**30-045-28483 SOUTH BISTI 32 E #001**

**Plug and Abandonment Procedure**  
**for**  
**DJR Operating, LLC**  
**South Bisti 32 E 1**  
**API # 30-045-28483**  
**SW/NW, Unit E, Sec. 32, T26N, R13W**  
**San Juan County, NM**

**CONDITIONS OF APPROVAL**

## Geologic Report

**Proposed Wellbore P&A Diagram**  
**DJR Operating, LLC**  
**South Bisti 32 E 1**  
 API # 30-045-28483  
 SW/NW, Unit E, Sec 32, T26N, R13W  
 San Juan County, NM

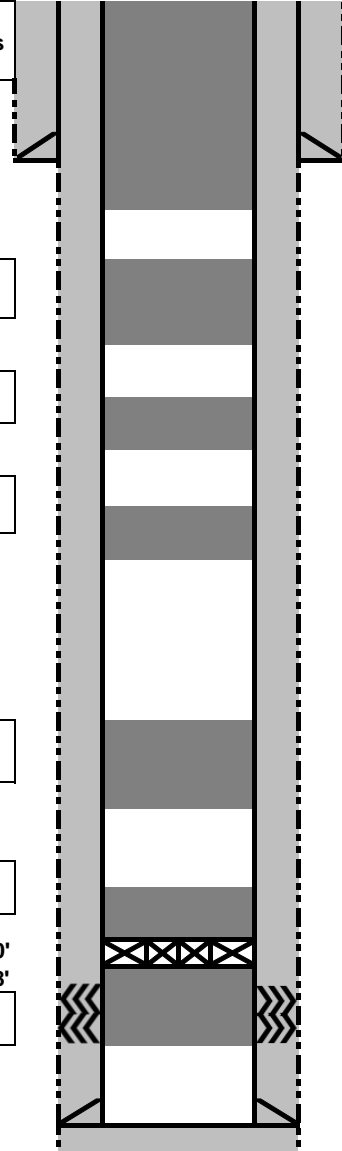
1. Plugging operations authorized are subject to the attached "General Requirements for Permanent Abandonment of Wells on Federal and Indian Lease."
2. Farmington Office is to be notified at least 24 hours before the plugging operations commence (505) 564-7750.
3. If casing does not test in procedure step 13 contact BLM.
4. BLM picks Cliffhouse SS top at 2656 ft. Add a plug from 2606 – 2706 ft.
5. BLM pics Fruitland top at 930 ft. Extend or add a plug to ensure coverage 880 – 980 ft.

-Please note that the depths for the Kirtland and Fruitland differ significantly, while the Cliff House and the Gallup formation depths differ slightly from the Operator's picks.

-The Ojo Alamo formation top is behind the surface casing and is protected adequately by the proposed plugging procedure.

- Notify NMOCD 24 Hours prior to commencing activities
- In addition to the BLM-approved plugs:
- OCD approves the plugs originally proposed by the operator.
